STATE OF MAINE
DEPARTMENT OF TRANSPORTATION
16 STATE HOUSE STATION
AUGUSTA, MAINE 04333-0016

January 19, 2023
Subject: Acadia Gateway
State WIN: 017163.03
Location: **Trenton**
Amendment No. 5

Amendment #5 Updates
-Added details 5,6,7

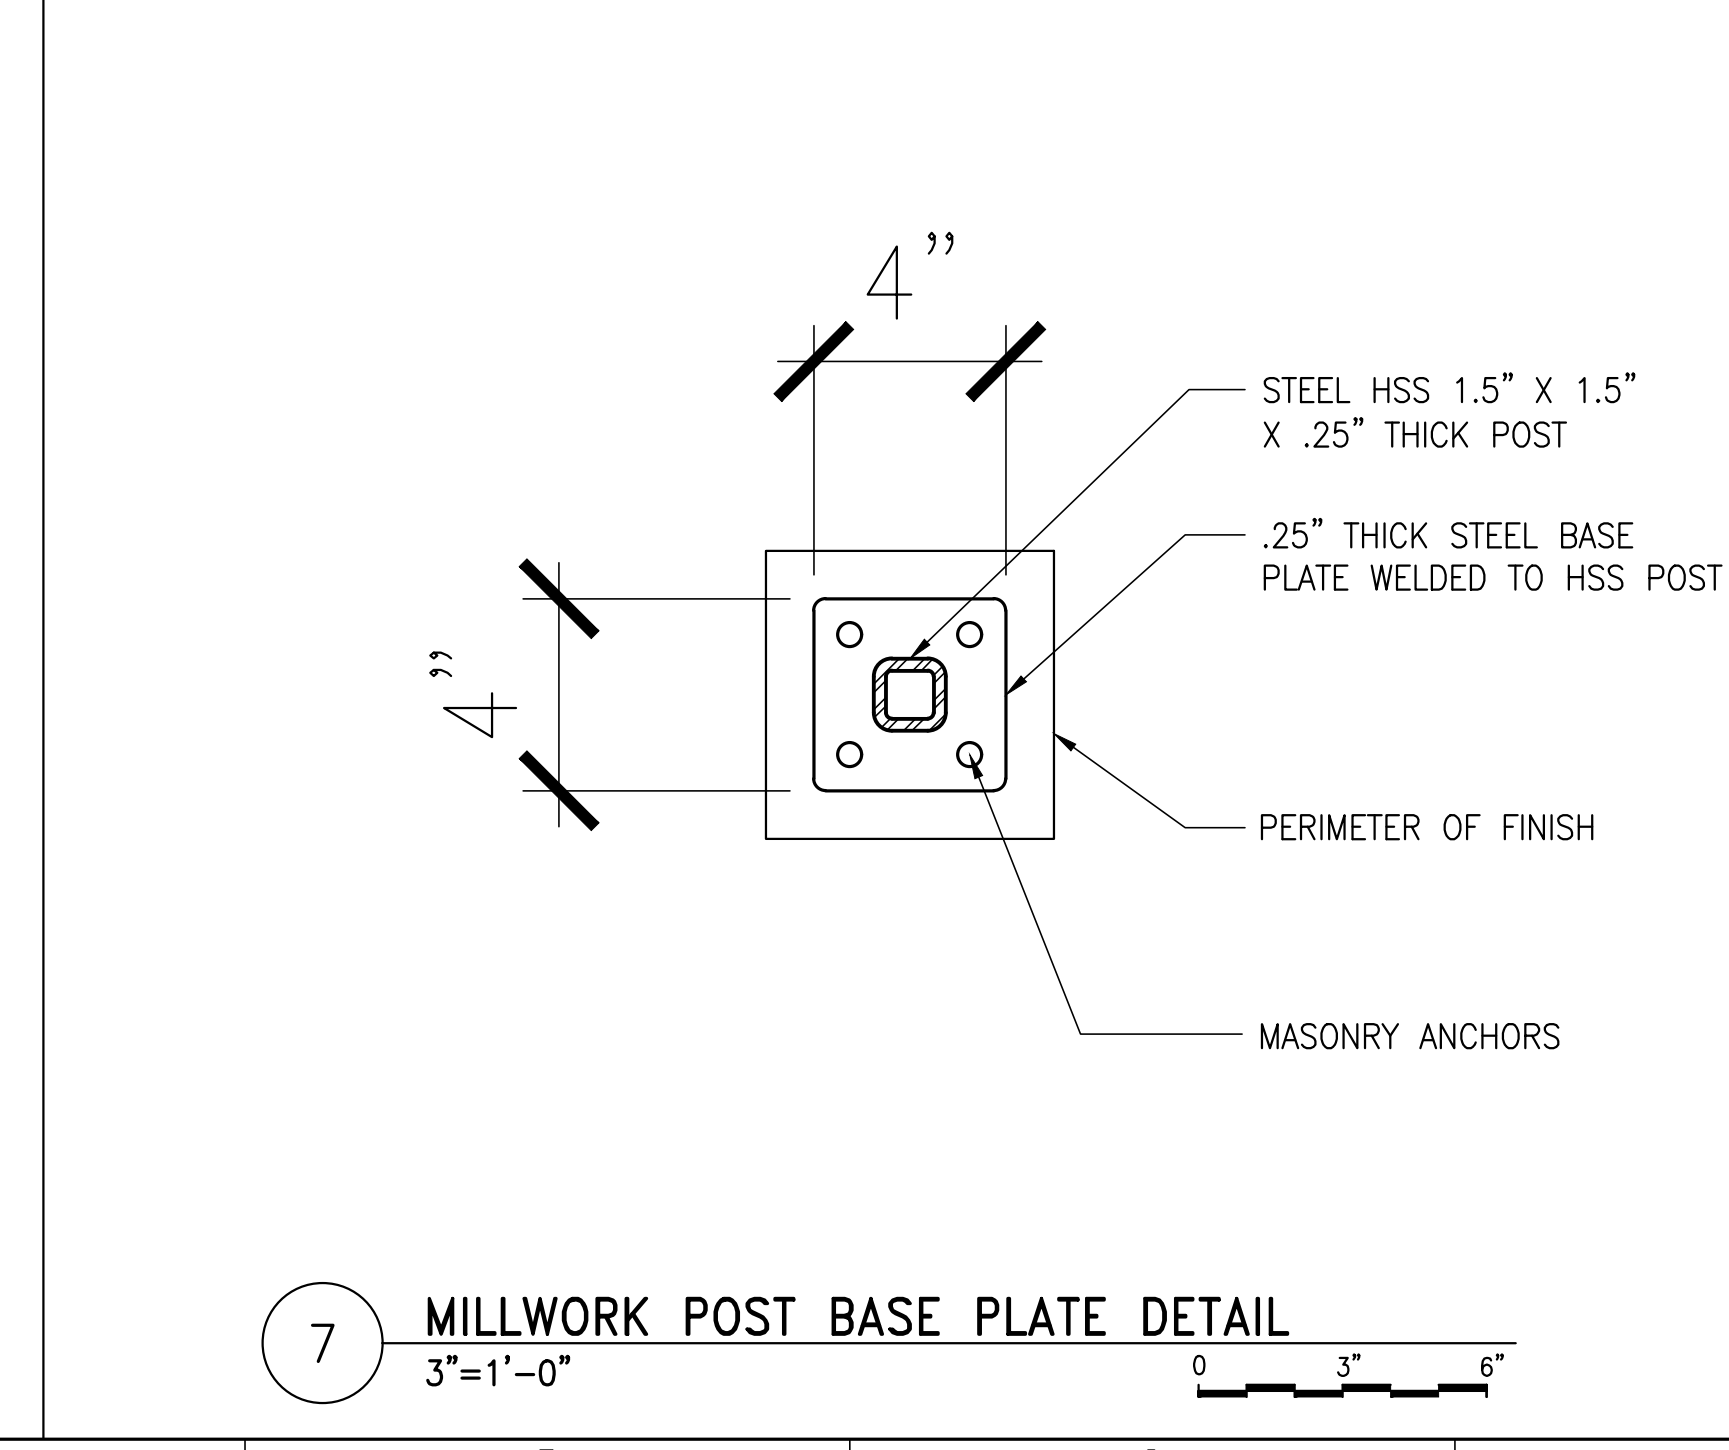
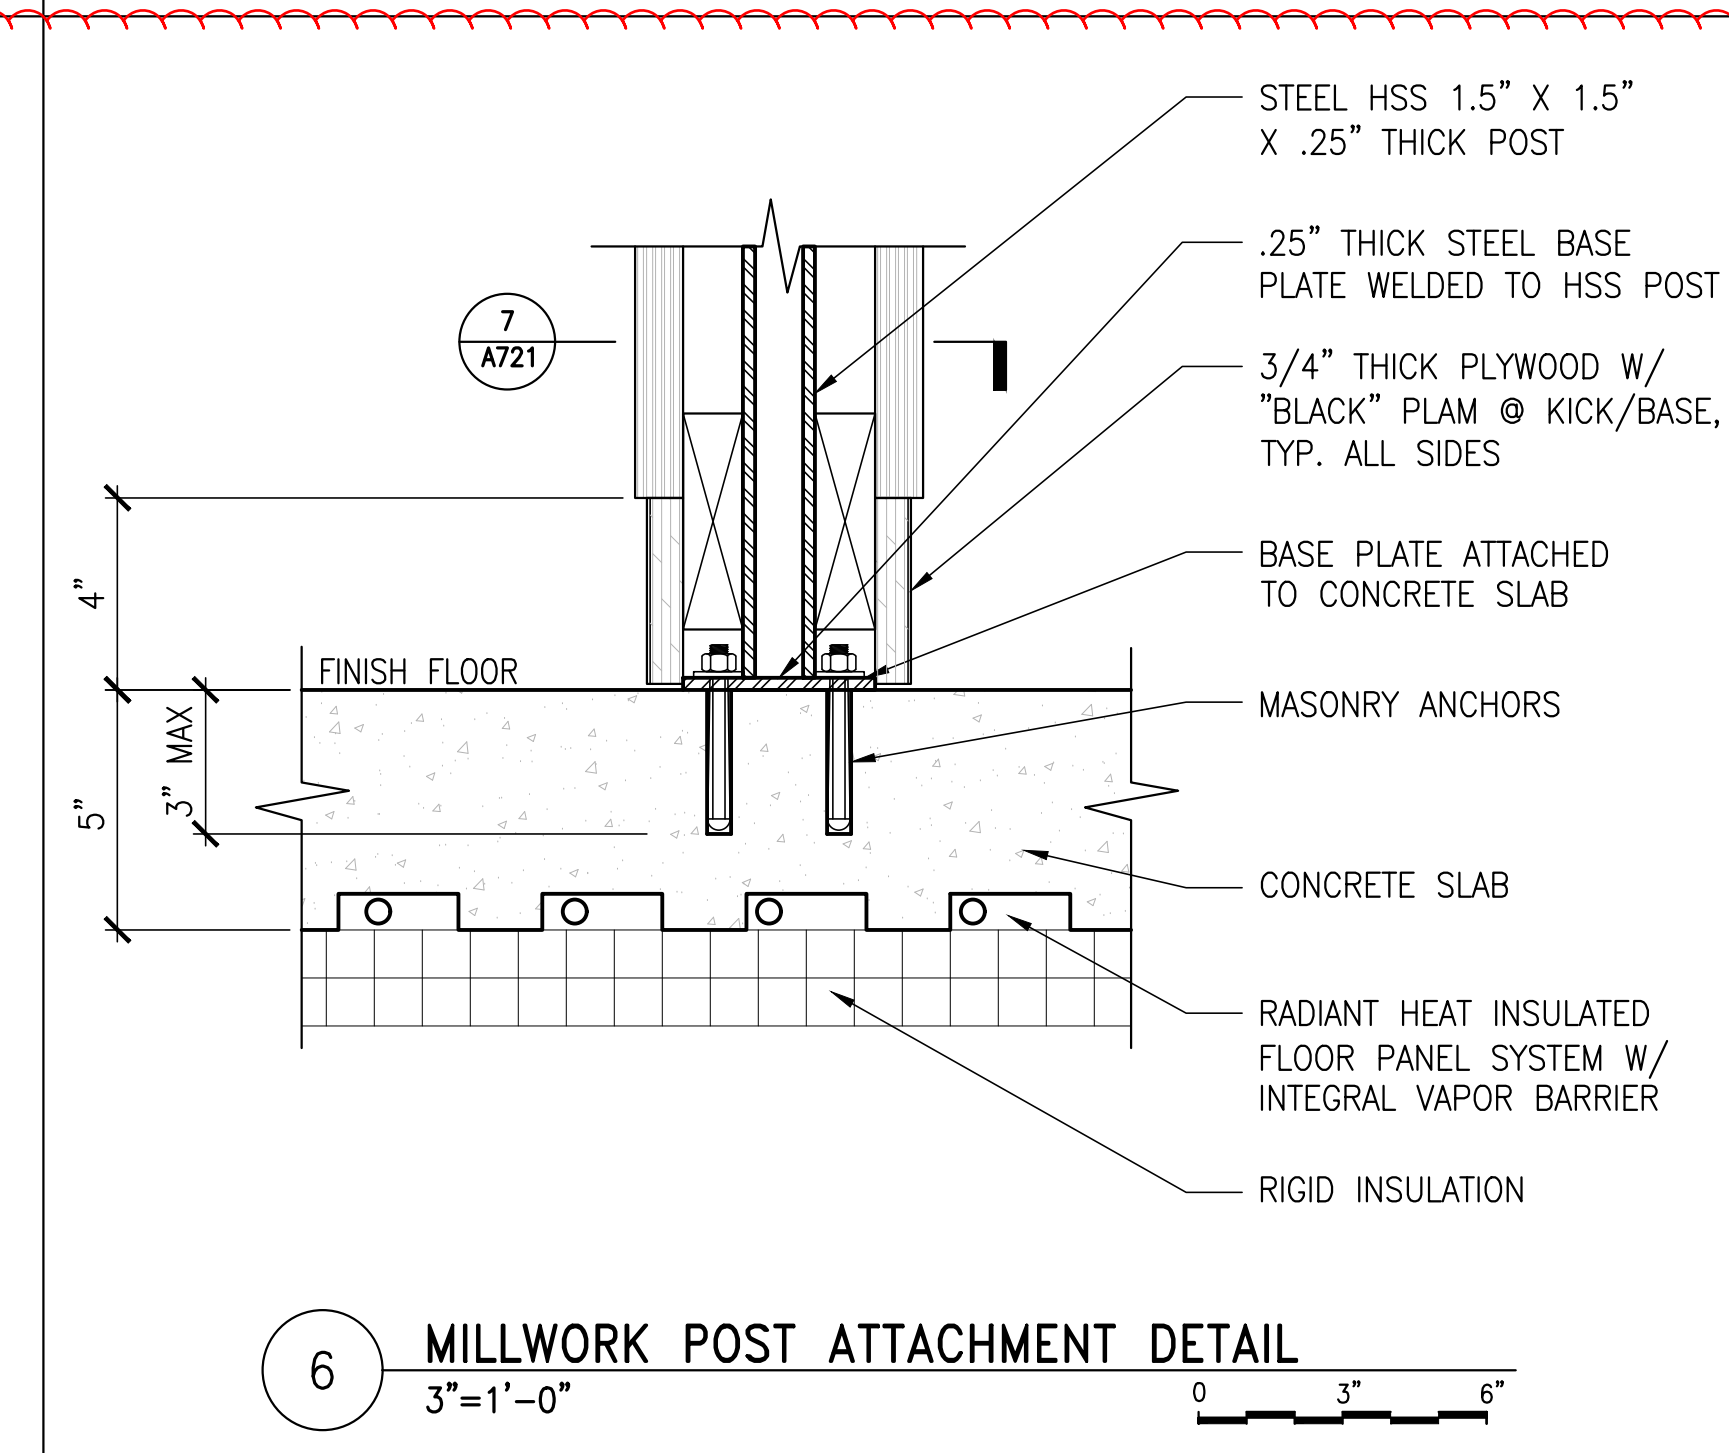
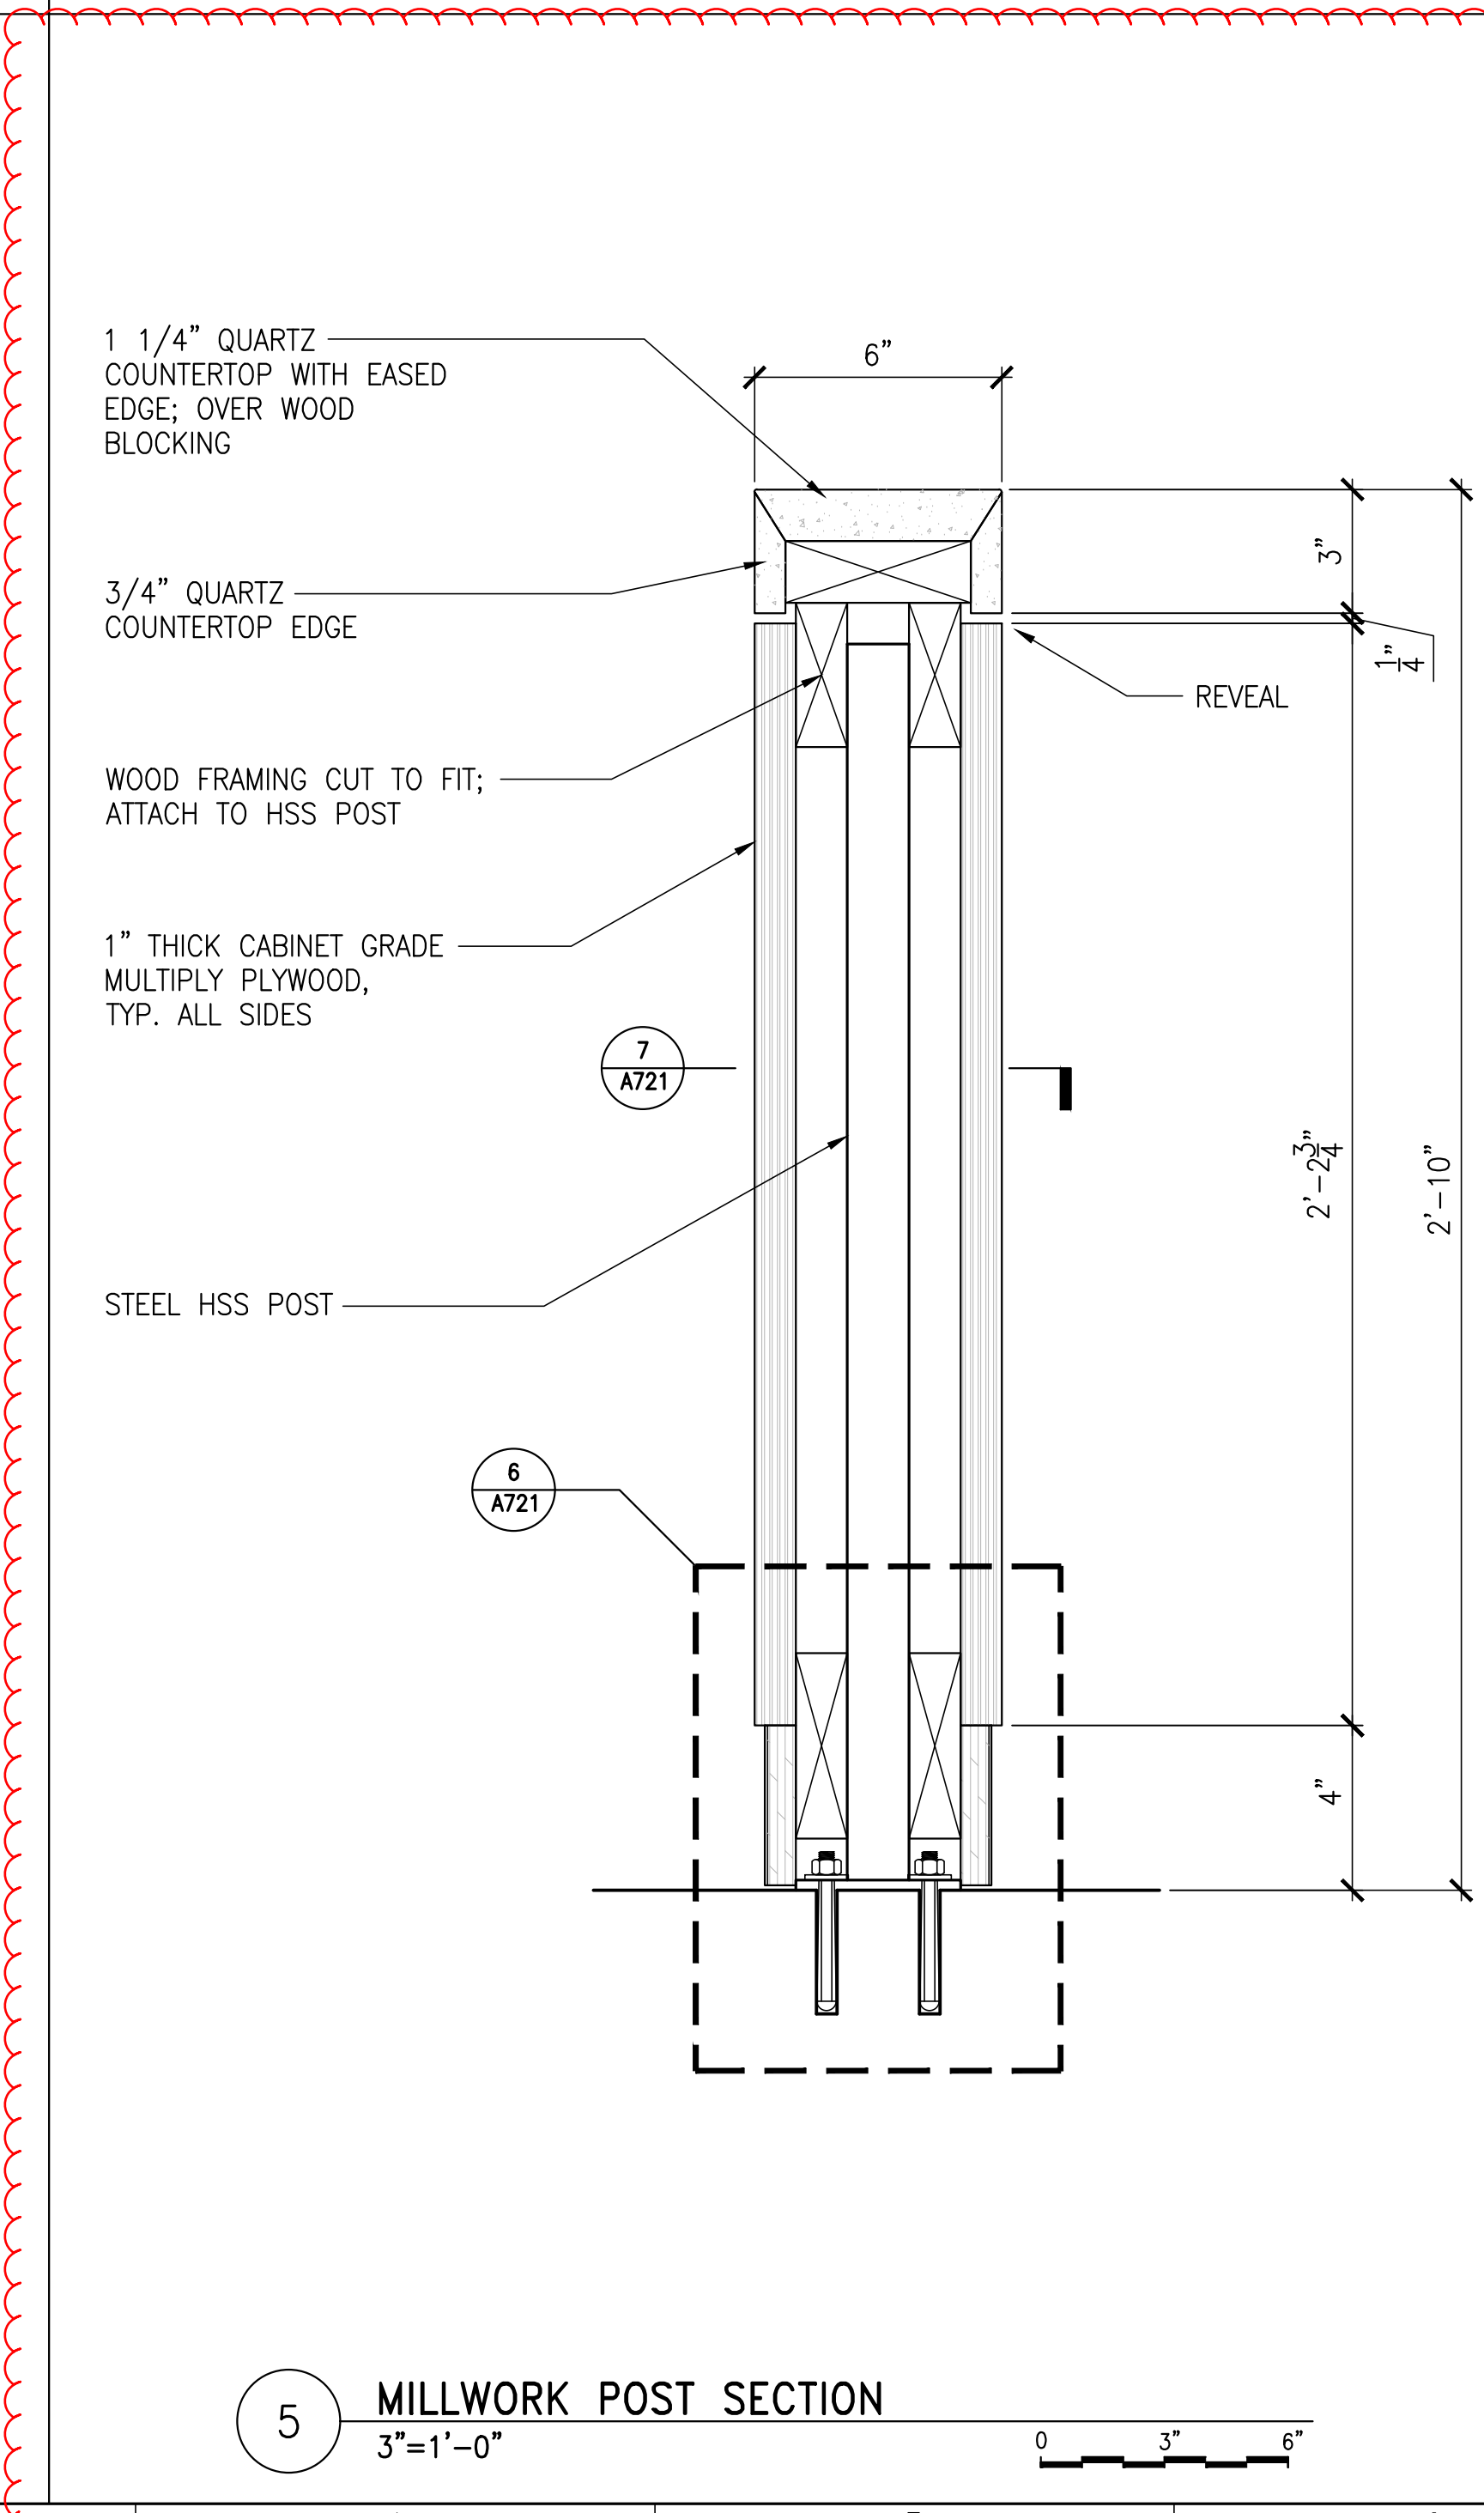
Question: There is a note about 2 counters/gates/panels at MW-03, Rm.#113 listed as TBD. Are details coming?

Response: Details for the two swing gates have been added to the drawings in Amendment #5. Sheets A202, A702, A703, A715, A721, A725 have been updated.
